TP153949 Modification Kit to Add Magnet Bracket Assembly.

PART AFFECTED: TP164386 Magnet Mounting Bracket

TP164386 MAGNET MOUNTING BRACKET

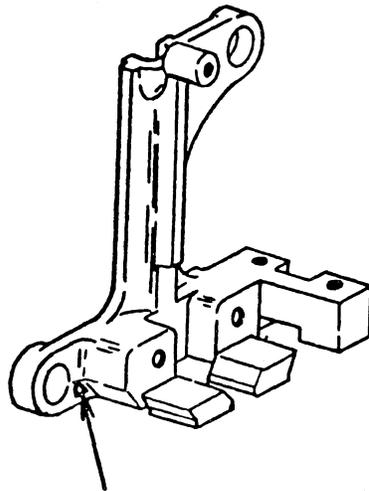
CHANGE: The manufacturing process for the TP164386 magnet mounting bracket is revised to eliminate the substance that causes the armature to hang up.

IDENTIFICATION: The TP164386 magnet mounting brackets manufactured by the revised process can be identified by the presence of a blue dot near the lower mounting hole. See Attachment Sheet 1.

**BLUE DOT IN THIS AREA INDICATES
TP164386 MAGNET MOUNTING BRACKET
MANUFACTURED BY THE REVISED PROCESS.**
